STATE OF NORTH CAROLINA
DEPARTMENT OF TRANSPORTATION

May 31, 2018

Subject: **Request for Modification to Individual Section 404 and Section 401 Water Quality Certification** for Fayetteville Outer Loop from I-95 South of Fayetteville to NC 24-87, Cumberland, Hoke, and Robeson Counties. Federal Aid Project No. NHP-0620(031), State Project No. 34817.3.13, TIP Nos. X-0002 B & C, and U-2519 AA, AB, BA, BB, CA, CB, DA, & E. Debit \$570 from WBS 34817.3.13

Subject: NEPA\404 Merger Team - Concurrence Point 4B Meeting
U-2519BA - Fayetteville Outer Loop from South of SR 1003 (Camden Road) to South of SR 1104 (Strickland Bridge Road), Cumberland County, Division 6

PERMIT DRAWING
SHEET 29 OF 39

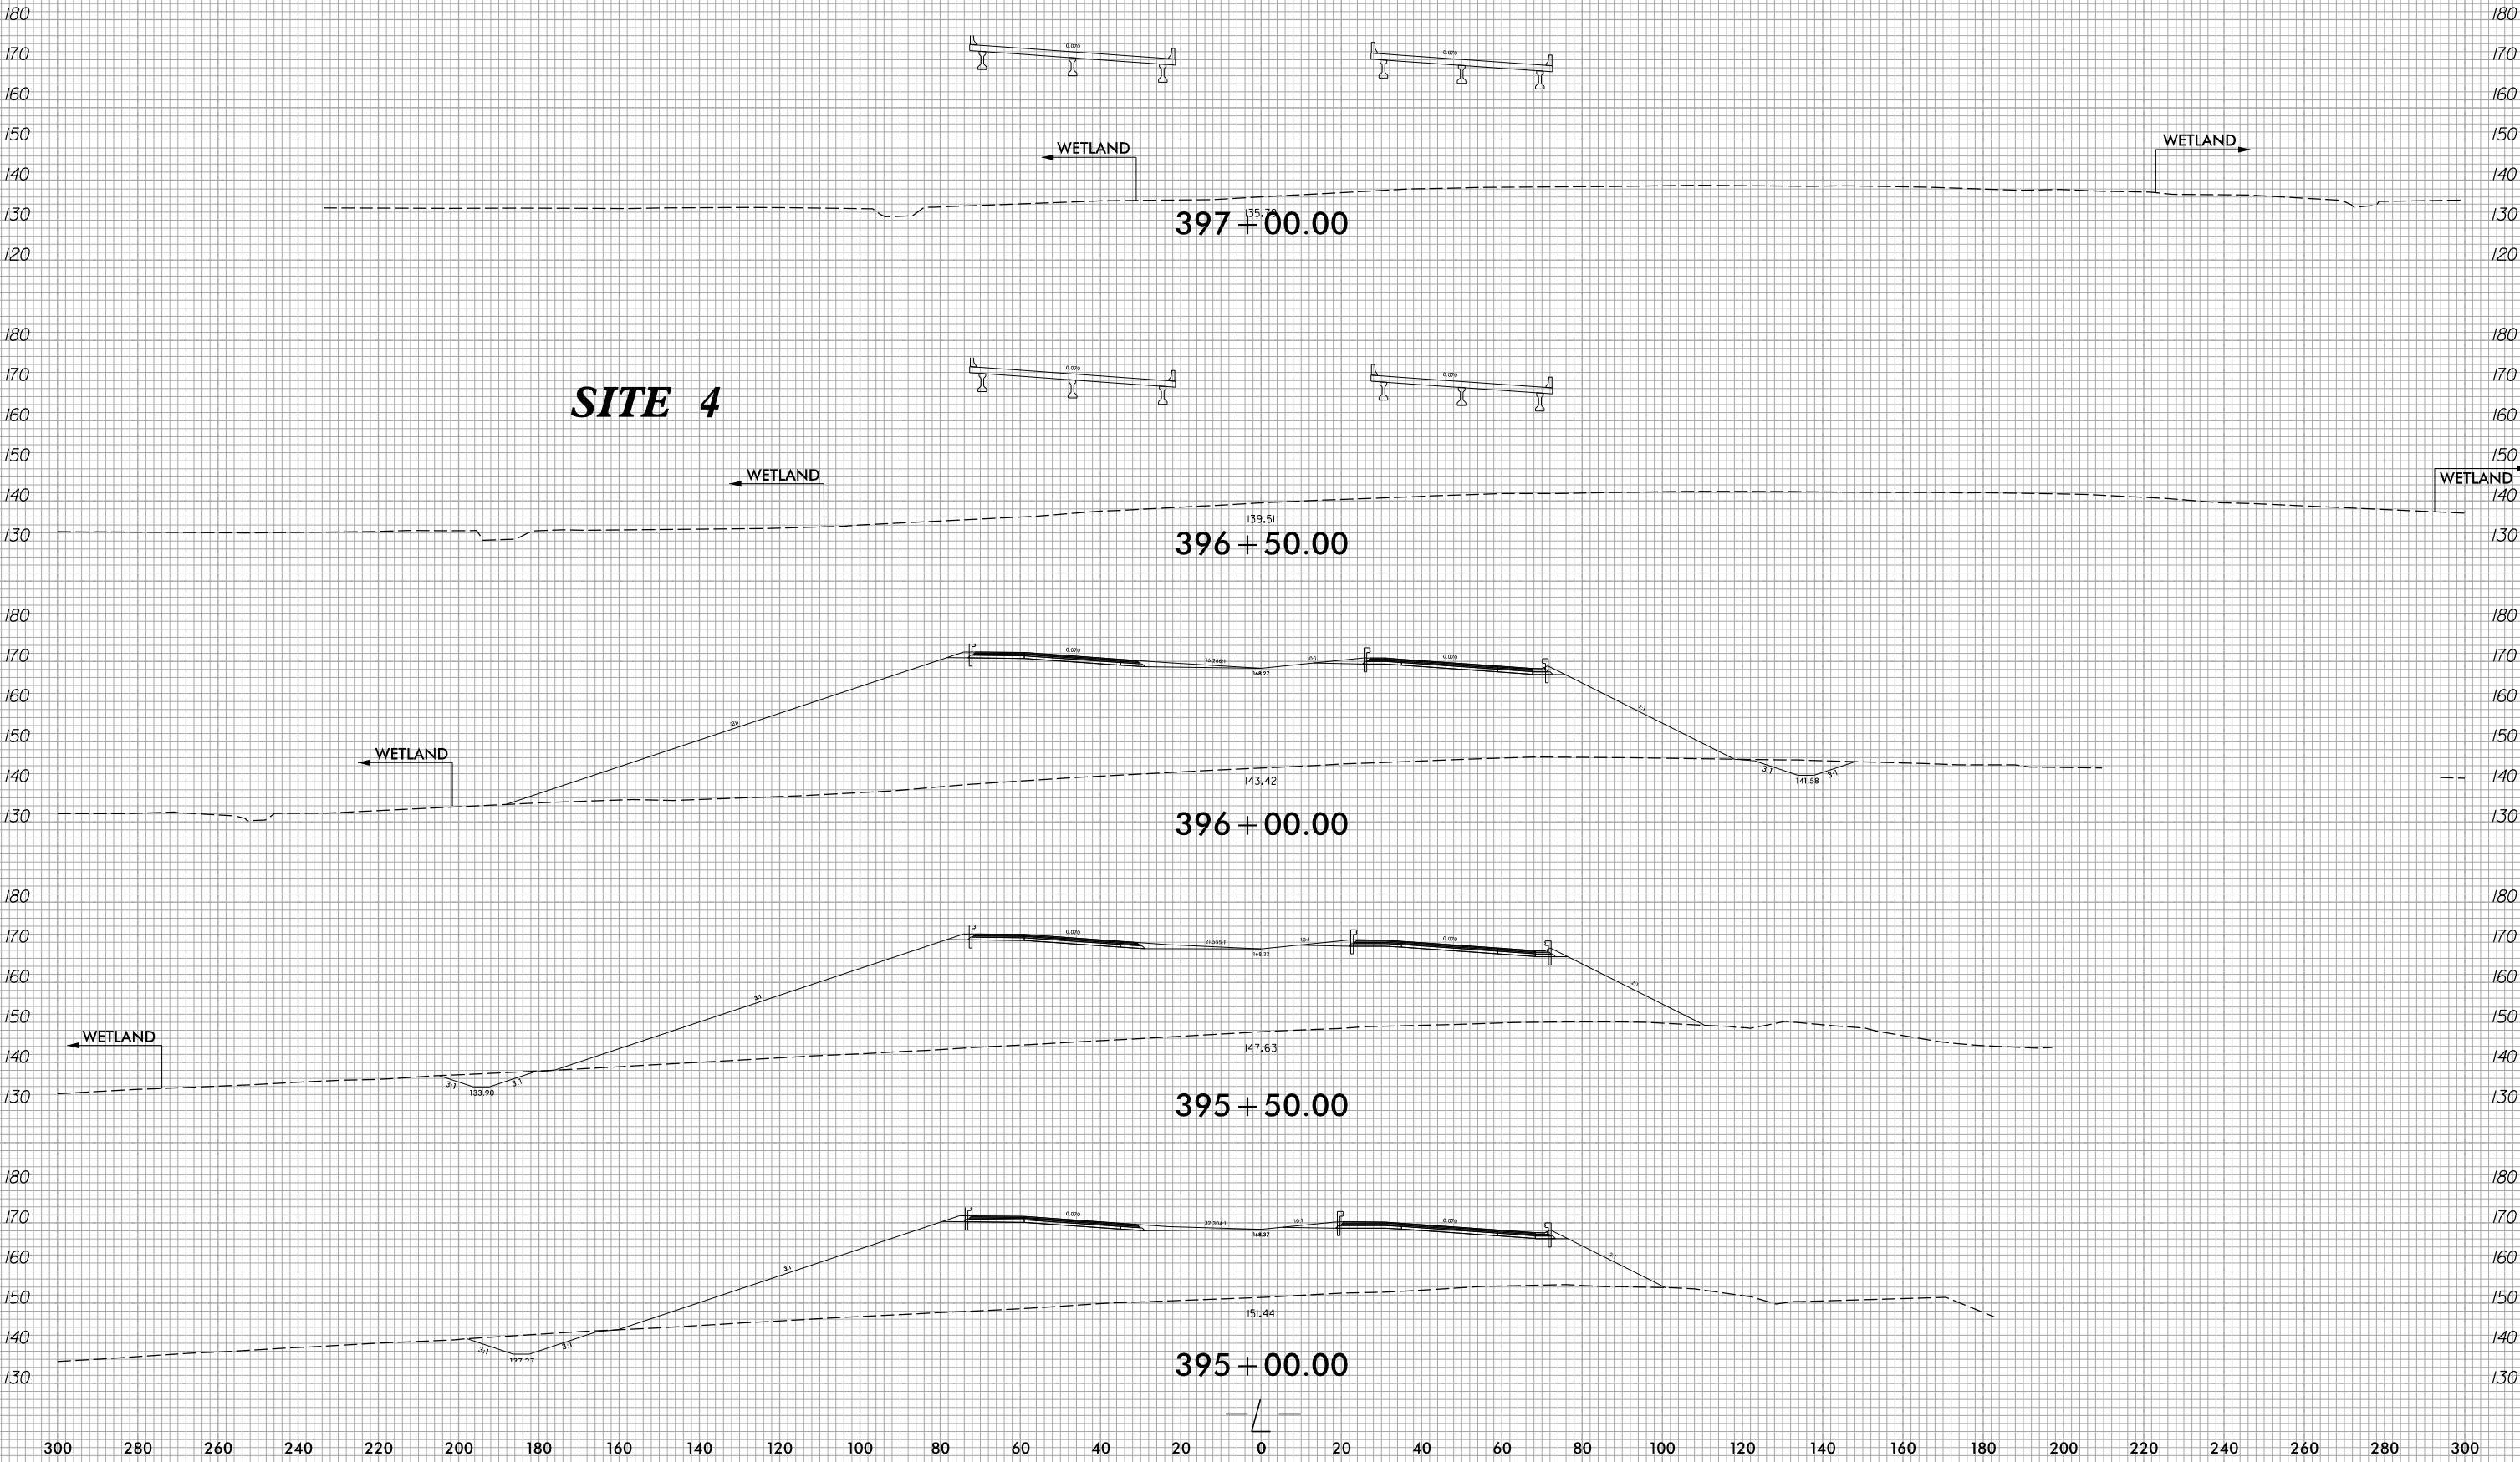
Site 4 (Permit Sheets 26-29): The site includes a bridge spanning the UT to Stewarts Creek and wetlands. No deck drains are required for the bridge. There is a minimum 15 foot offset between the wetland boundary and the toe of slope. A temporary work bridge is provided for construction and is shown on the permit drawings (dashed line under bridge). Currently the design of the work bridge is under review from the structures unit. It is noted on the final summary sheet that the work bridge impacts are not final until approval of the work bridge.

Site 2 – 72” RCP –L- 545+11 (Permit Drawing Sheet 2)

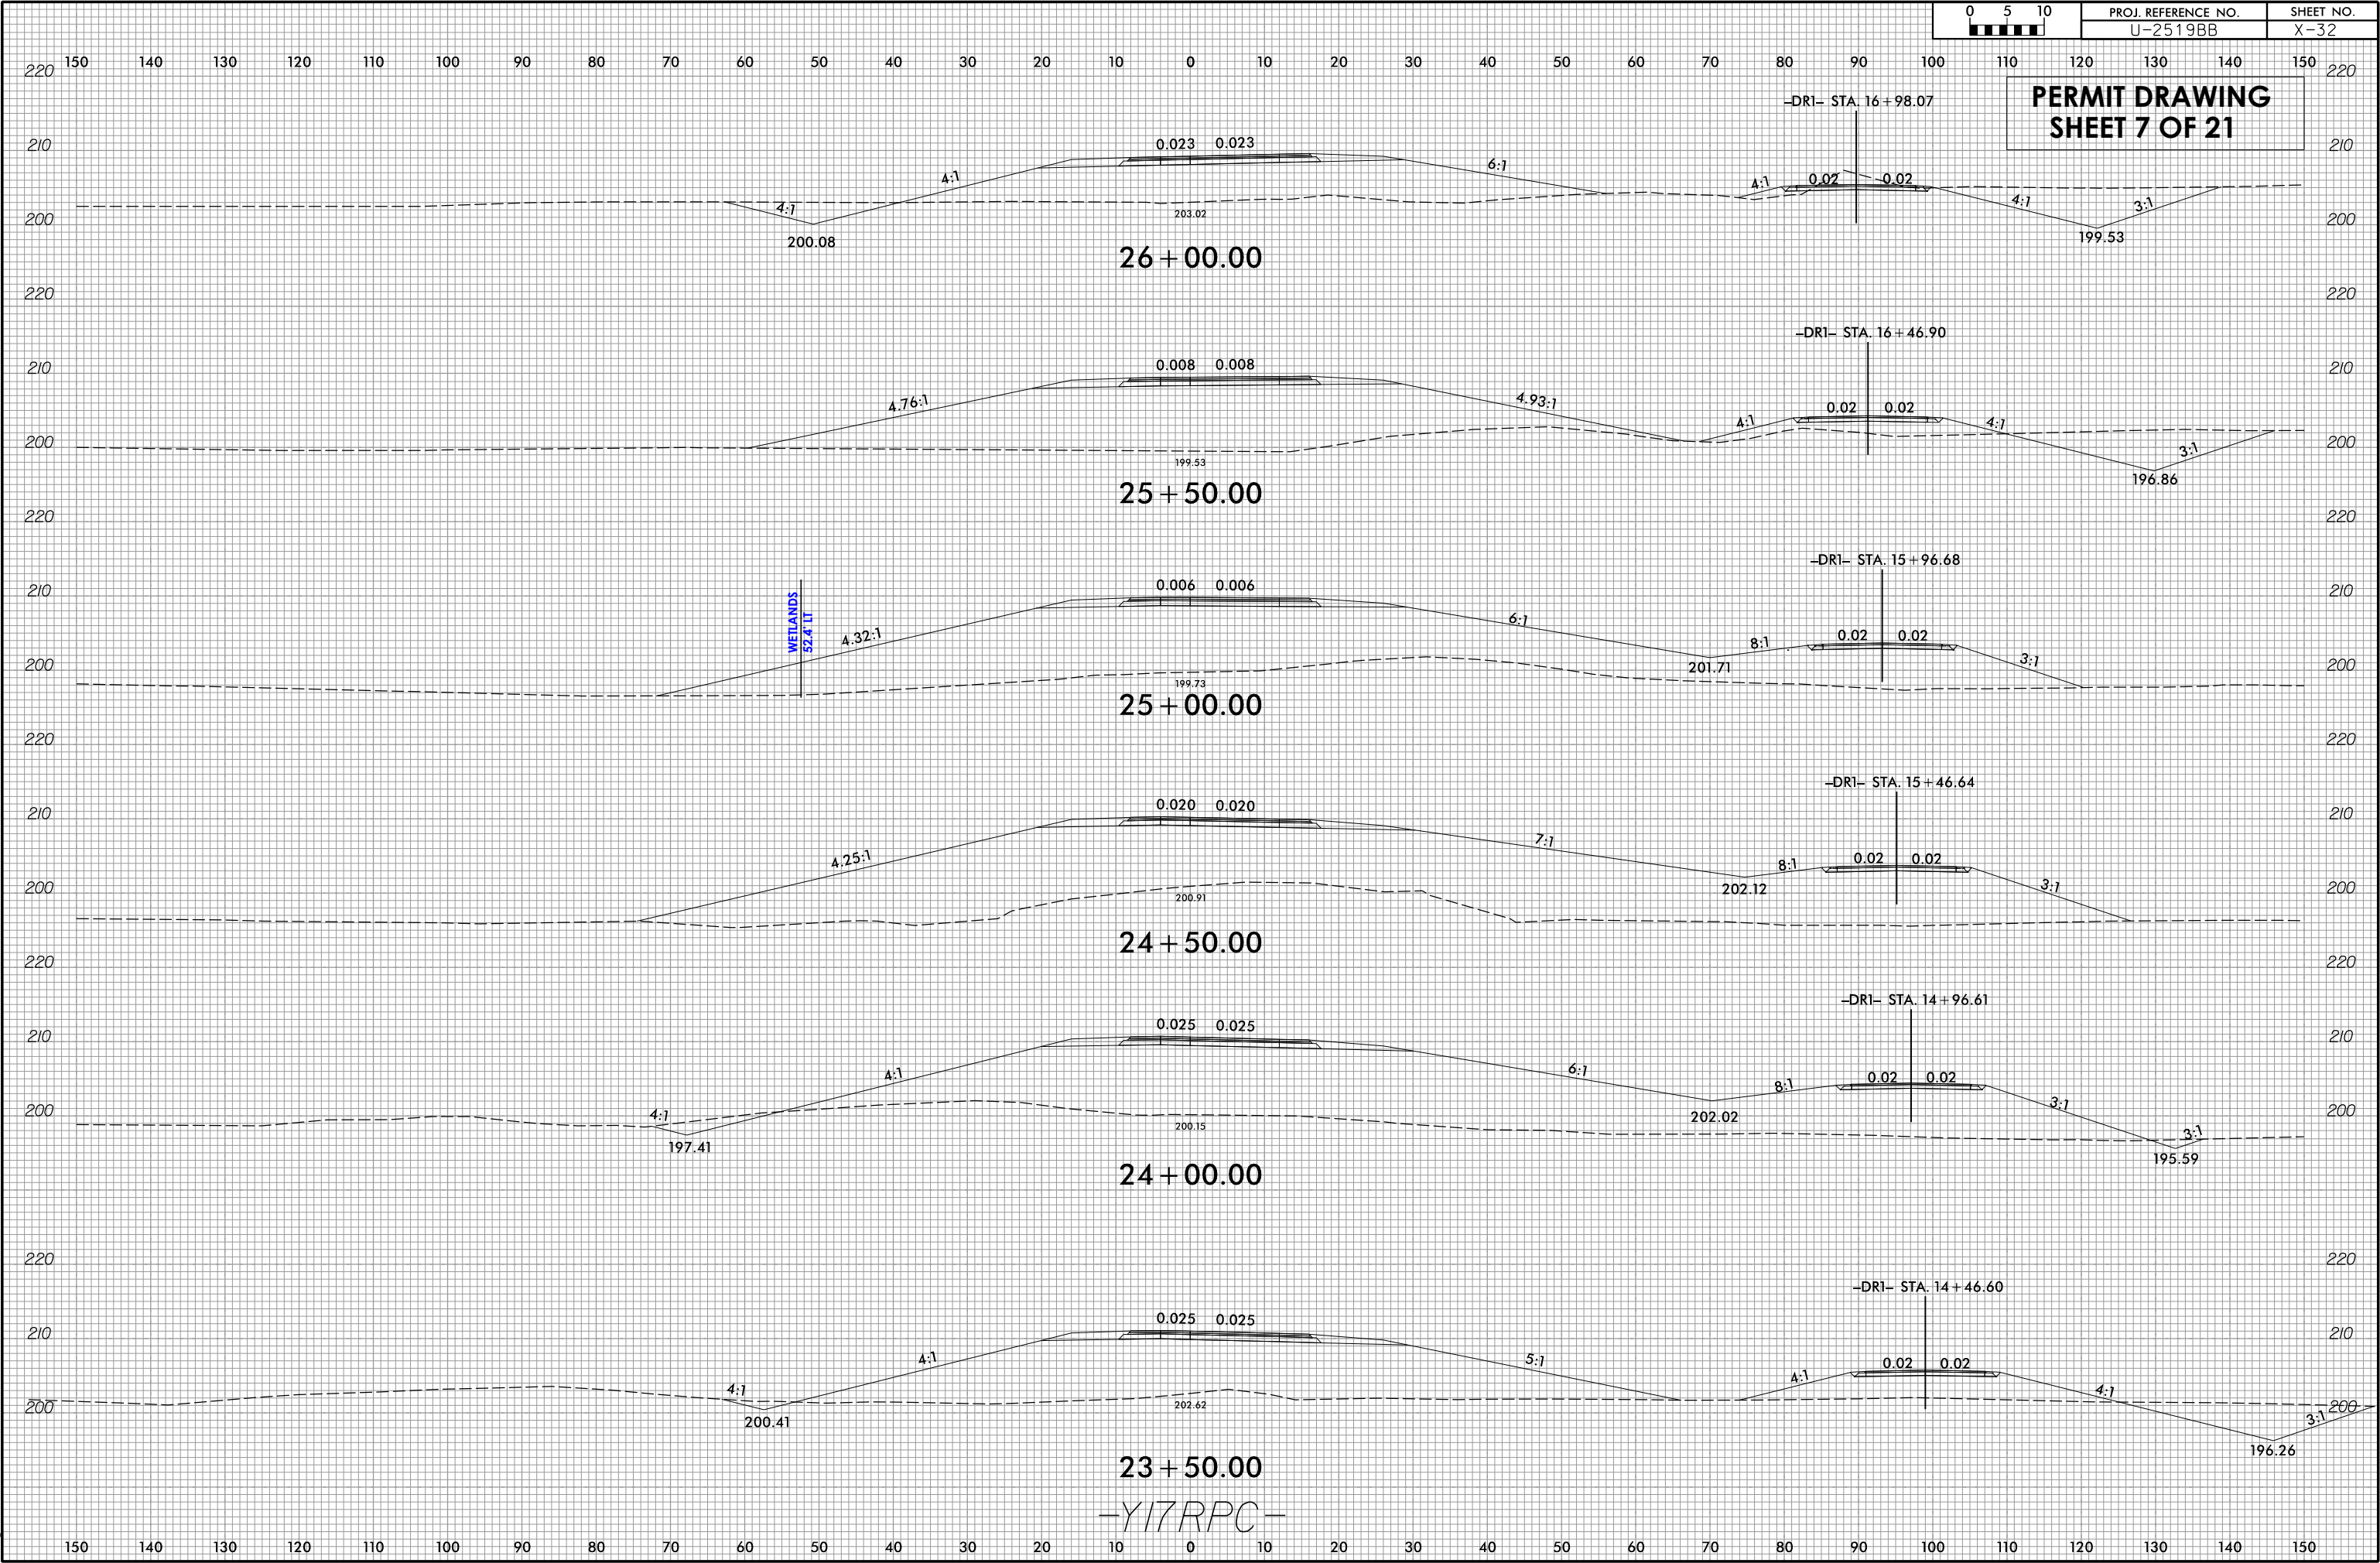
- A 72” RCP (buried 1 ft) with standard riprap apron is proposed at –L- 545+00. Permanent impacts for the pipe, as well as temporary impacts and mechanized clearing have been shown beyond the proposed fill slopes to account for construction/installation activities.
- NCDWR requested that the design be evaluated to consider not burying the 72” RCP since a JS is not present, only wetlands exist at the outlet of the 72” RCP. Pipe will be revised to 66” unburied.
